GWINNETT COUNTY
DEPARTMENT OF FINANCIAL SERVICES
PURCHASING DIVISION

ADDENDUM #2
BL016-26, Library Administration Headquarters Renovation Project

This Addendum forms a part of the Contract Documents and Construction Drawings and modifies the original Bid Documents for the above-referenced project.

PROJECT NO. 20-24092.00
DATE 12.01.2025
SHEET TITLE DETAILS
SHEET NO. C4.01

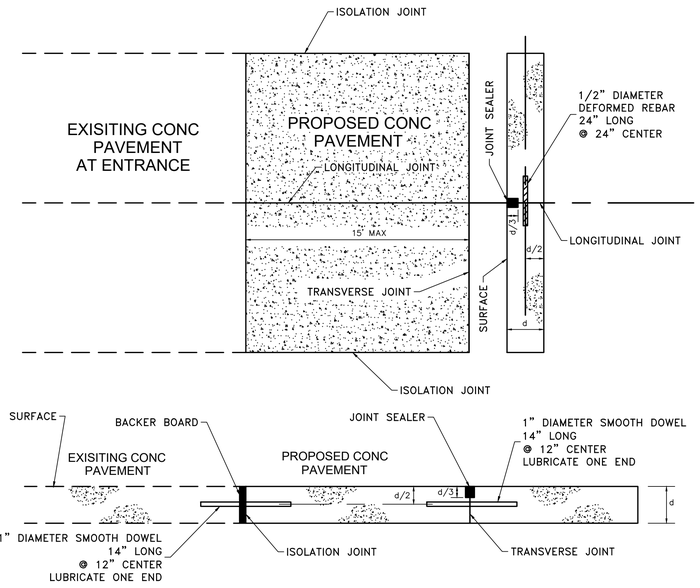
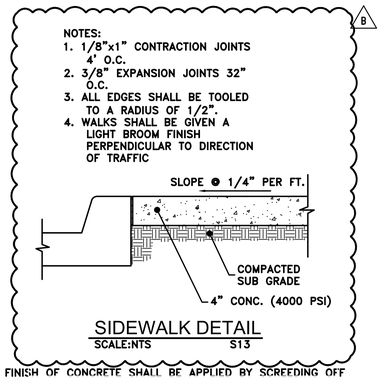
A20. The limits of each repair are indicated by the hatch pattern shown in the legend on the Pavement Plan. The tie-in location at Lawrenceville Highway is shown as revised on the Pavement Plan. Areas of asphalt pavement removal and replacement shall be full-depth repairs, including base and subgrade remediation, to ensure proper subgrade compaction, as revised on Detail Sheet C4.01 enclosed.

10 A4.02 HEADER DETAIL - TYP.
1 1/2" = 1'-0"

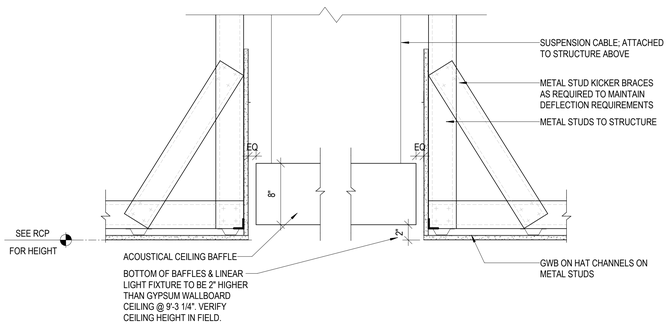
Q12. Please provide specs for the Demountable Partitions.

A12. Detail 10/A4.02 has been revised to include more information, and a new detail has been added to A9.62 to provide additional information about the demountable partition.

A-2

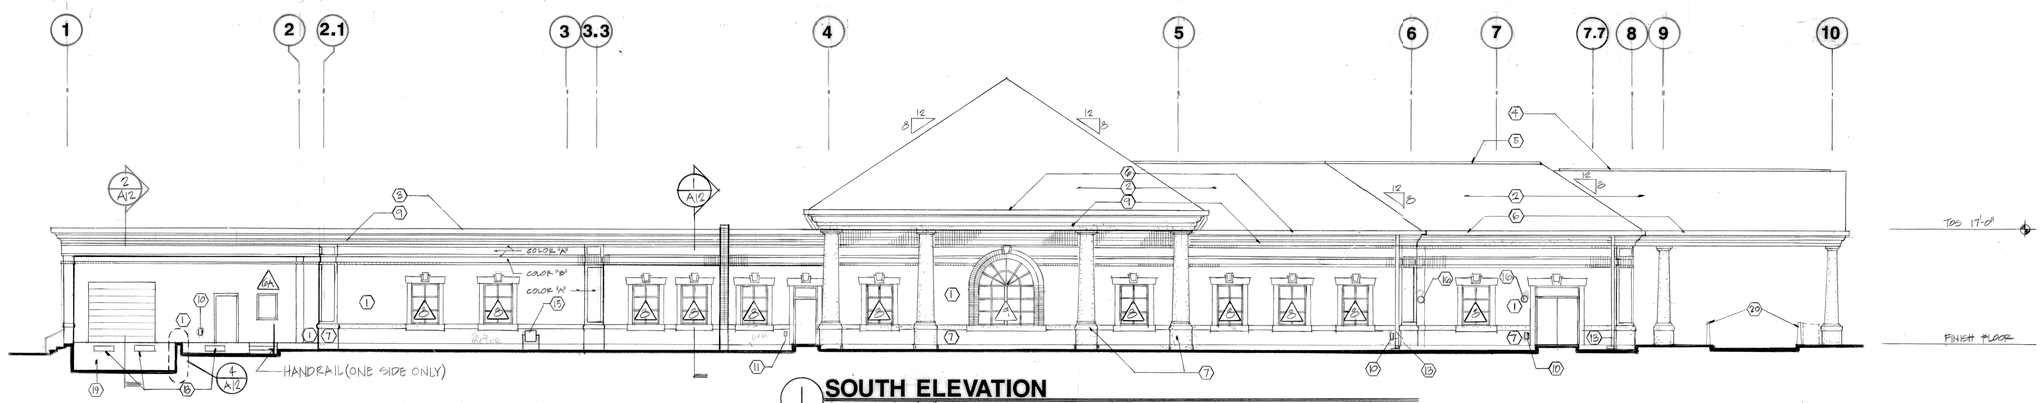
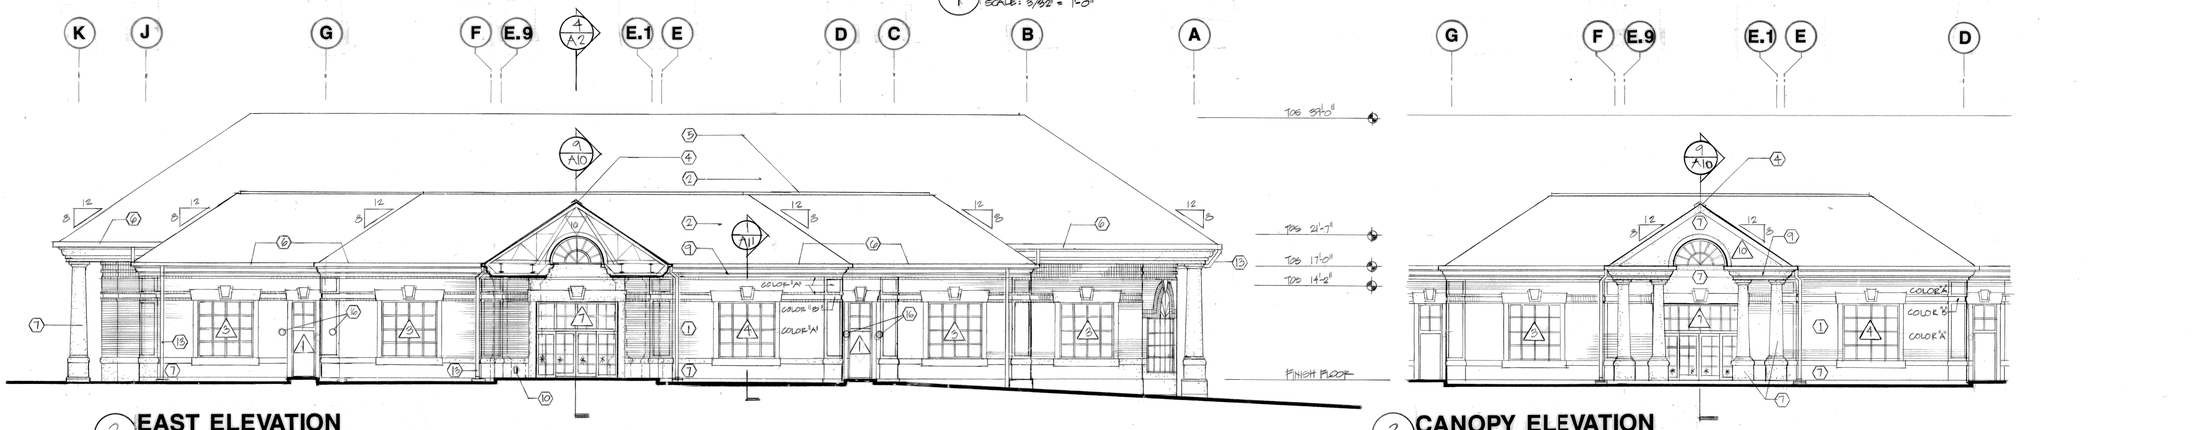
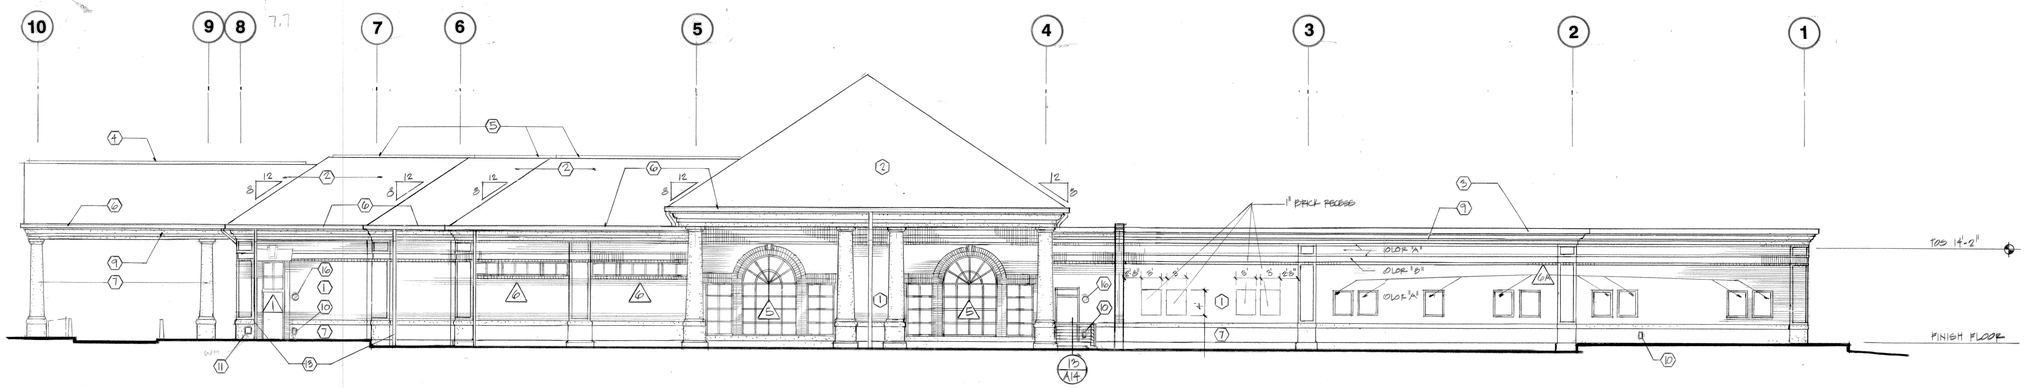
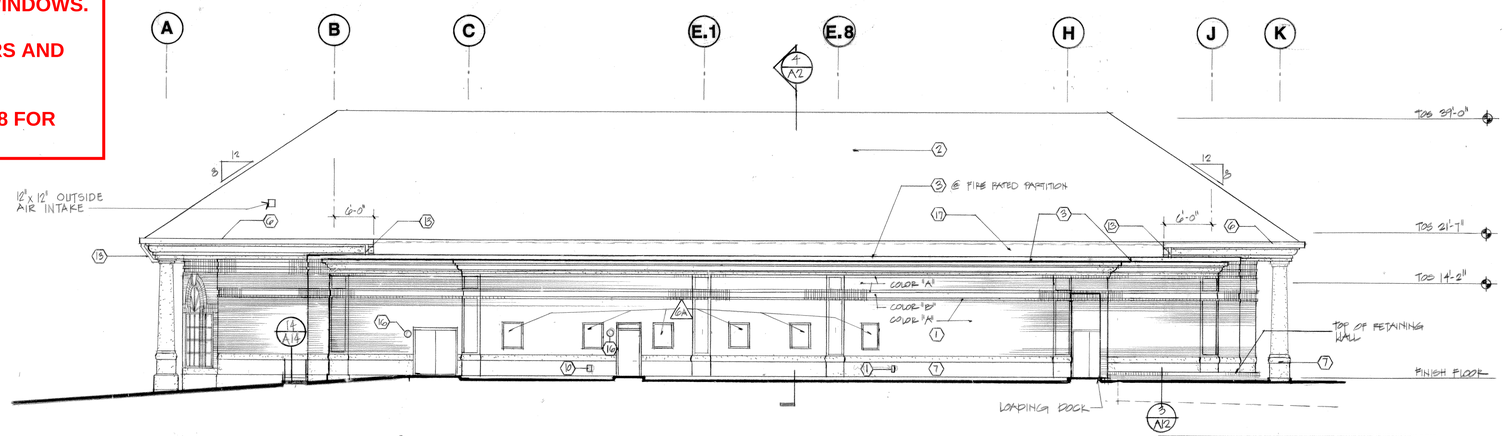
C3. Refer to enclosed existing building design intent drawing sheets A-2, A-3, and A-15, dated 12/09/1988, for illustration of the exterior doors and windows requiring re-sealing and re-painting of steel lintels. Refer to the General Notes 16 and 17 on drawing sheet A2.02 for additional information.

REMOVE EXISTING SEALANT AND BACKER ROD, AND INSTALL NEW BACKER ROD AND SEALANT AT EXTERIOR DOORS AND WINDOWS.

PREPARE AND PAINT STEEL LINDELS AT EXTERIOR DOORS AND WINDOWS.
